PROJECT Water Control Structure at
Salt Bayou

BORING 91-203

Review of Aviles Report
on Salt Bayou Water Control Structure

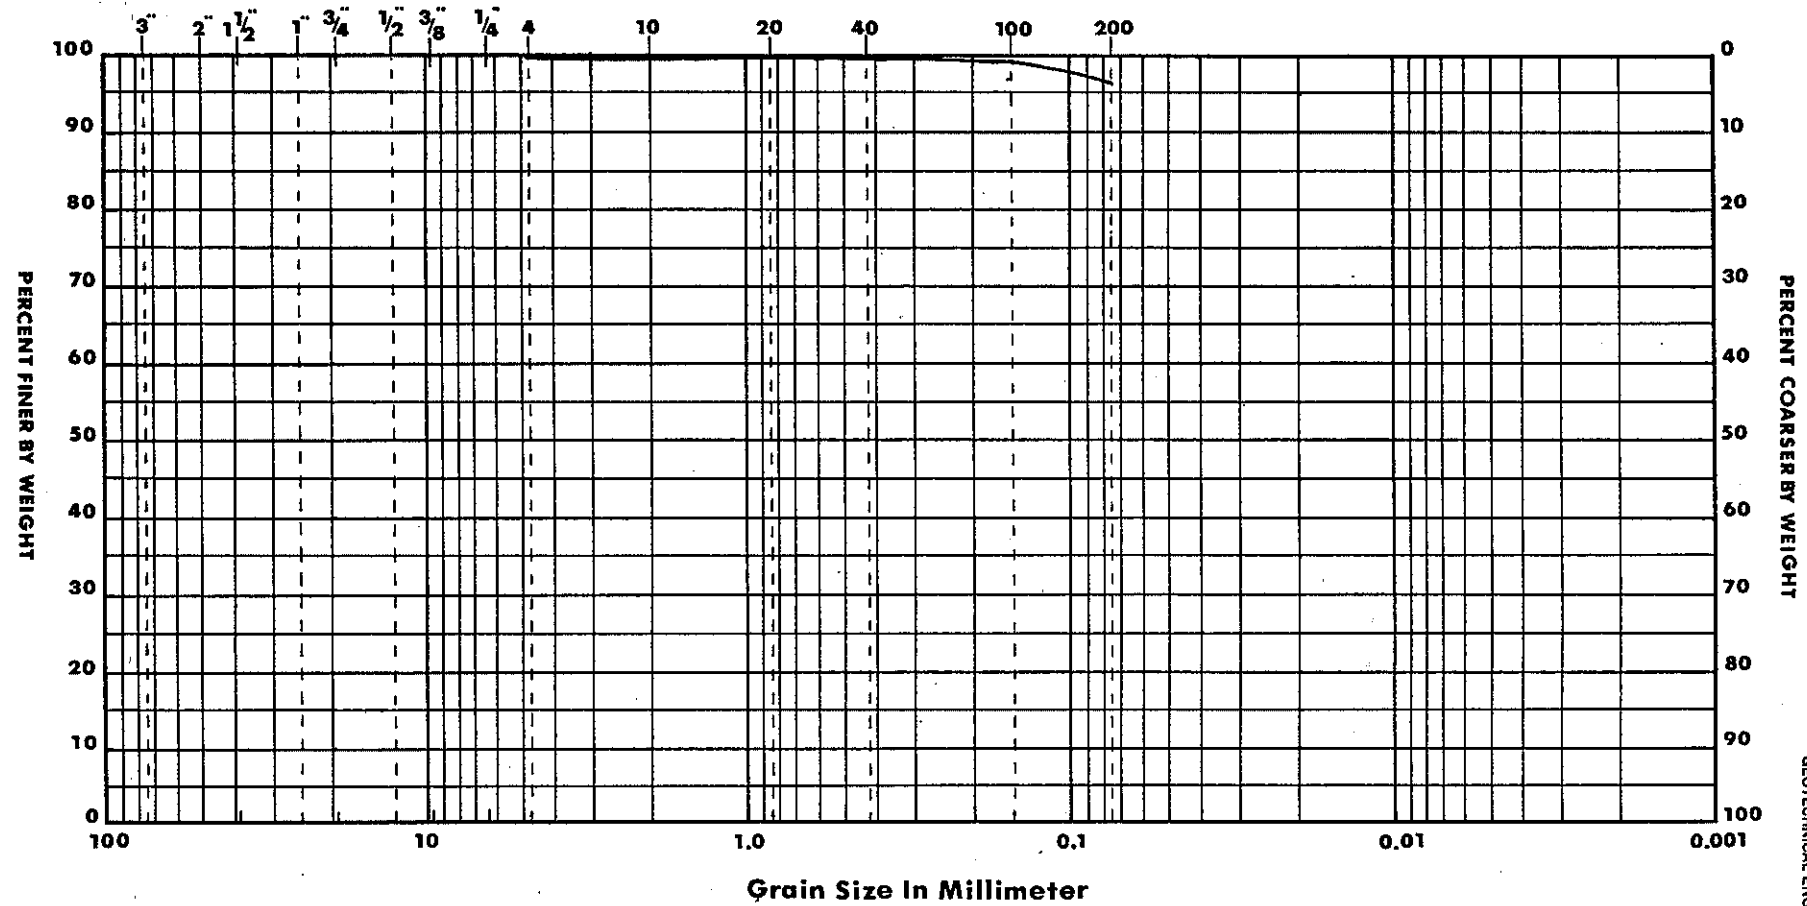
1. The plates showing description of materials, moisture content, unit dry weight, shear strength and atterberg limits are somewhat misleading. The presentation of unconfined compressive stress as a shear strength does ^{not} ~~ent~~ appear appropriate. Shear strength is usually taken as one half the unconfined compressive stress.

2. A comparison of the plots of pocket penetrometer readings with those shown on the driller's log appears to indicate that most if not all of the field readings were used on the plots. The contracts states: "The consistency of undisturbed cohesive materials shall be determined in the laboratory by taking pocket penetrometer readings in accordance with procedures outlined in Paragraph 8.6." Were pocket penetrometer readings taken in the laboratory?

3. A number of the torvane readings shown on the plots indicate no shear strength. What in fact were the torvane readings? A tabulation of the torvane readings should have been presented on the Summary of Laboratory Test Data.
